REQUEST FOR INFORMATION **DATE:** March 27, 2017 **NO.:** RFI-495

Project Name: 15051-Webster University Interdisciplinary Science Building Project No.: 15051

Subject: Barrier free eyewash conflicts

DRILL DETAIL "A"
(NOT TO SCALE)

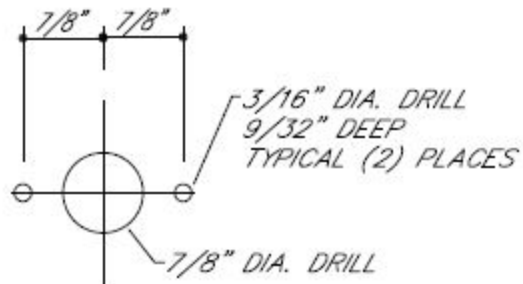
As noted on the returned shop drawings, the eyewashes have been updated to the barrier free ADA eyewash and placed in the drawings. There are 3 instances of conflicts where the eyewash extends past the edge of the sink. Please advise. Images handled.

NOTE: EYEWASH LOCATION @ S-5
SINK MISSES SINK PLEASE ADVISE

Response: Option-1: Move the eyewash closer to the faucet provided its within the manufacturer's spacing recommendation.

Option-2: If the above approach still results in eyewash extending past the sink edge, then move the faucet & eyewash such that they are located equidistant from sink edges.

S-5 sink with EW are only in two rooms 289A and 289B. There are three locations submitted, provide room numbers for sink locations submitted in RFI for confirmation.

DRILL DETAIL "A"
(NOT TO SCALE)

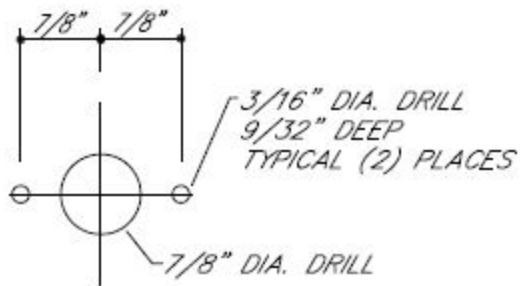
NOTE: EYEWASH LOCATION @ S-5
SINK MISSES SINK PLEASE ADVISE

DRILL DETAIL "A"
(NOT TO SCALE)

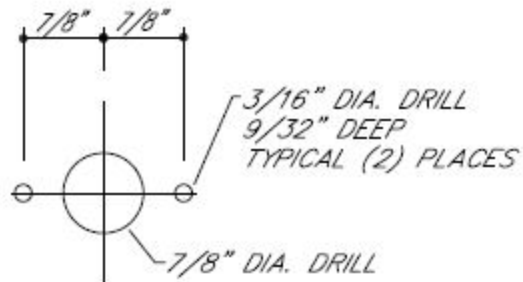
NOTE: EYEWASH LOCATION @ S-5
SINK MISSES SINK PLEASE ADVISE
